# Access Compliance Report

## Public Rights-of-Way

### (Pedestrian Signals)

Intersection ID: N/A	Main Street:	Cross Street: N/A	Location: N/A
ADA ID: 0E87B893FD3C	Signal Type: One Push Button-APS	Overall Compliance: No	Severity Score: BTN 1: N/A BTN 2: N/A No BTN: N/A
Codes/Mitigation Info/Possible Solution		Field Measurements/Component Compliance

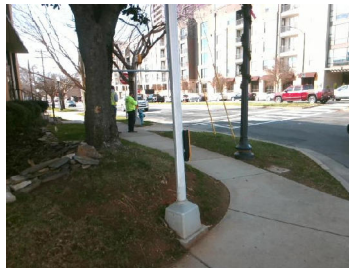
Surveyor Notes: OUT OF SERVICE

PROW/ADA: TMUTCD 4e.08, R209.1, TMUTCD 4e.10, MUTCD 4e.08, R104.2,

Possible Solutions: Replace Signal Push Button With APS Button on New Post. Remove & Relocate Sign.
